## 8.0 ANALYSIS OF UPPER RESERVOIR BARRIERS

### 8.1 OVERTOPPING ANALYSIS

FIGURE 8-7

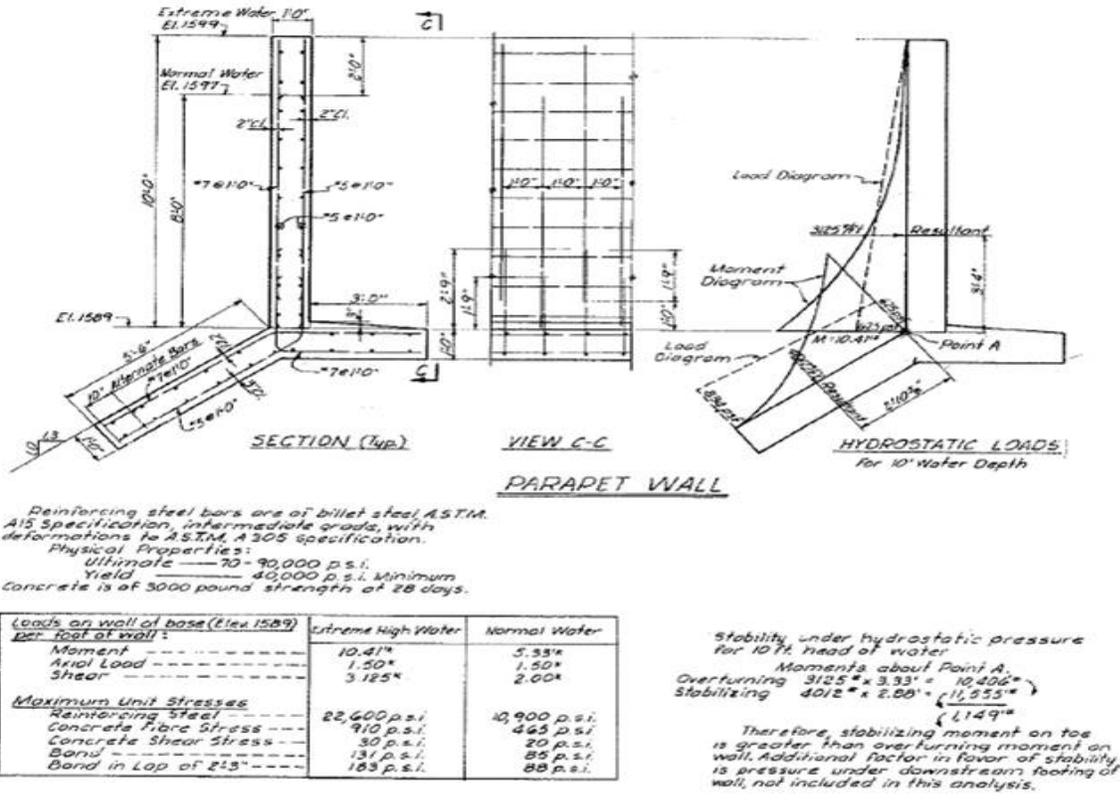
We have a few comments on this analysis. Firstly, the designer summed moments about Point A at the downstream bottom corner of the vertical stem of some of the acting forces - not all. Theoretically, one can sum moments about any point so long as all forces and moments are considered. Practitioners normally sum moments about the downstream toe, i.e., about the lower right hand corner of the base and all of the forces and moments would be considered.

Secondly, the originating analyst ignored the weight of the concrete and the soil pressure, and thirdly, the analyst ignored any uplift pressure that might develop under the foundation when the water level is in the range of El. 1598.

Our conclusion on this matter is that the original analysis would not be acceptable in a modern regulatory environment.

**FIGURE 8-34**

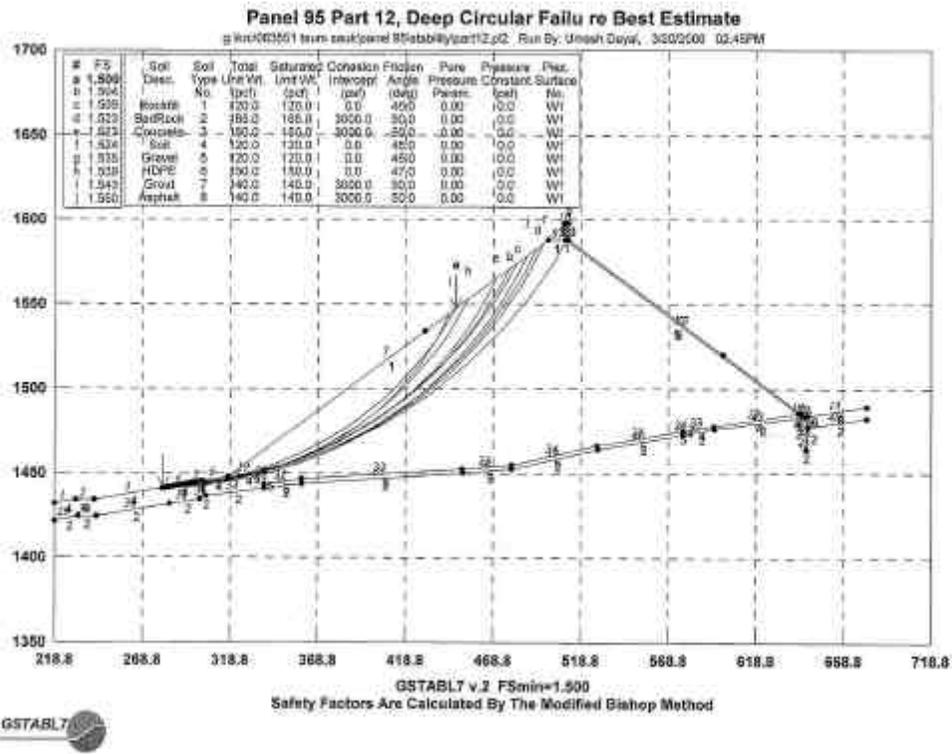
**Independent Check:** As a check, RIZZO has independently performed the slope stability analyses using the same geometry and strength properties as used in the original stability calculations—not the properties that RIZZO interprets to be appropriate. The results are presented on *Figure 8-34*. These results show a factor of safety of 1.5 as reported in the original calculations prepared by the original designer.
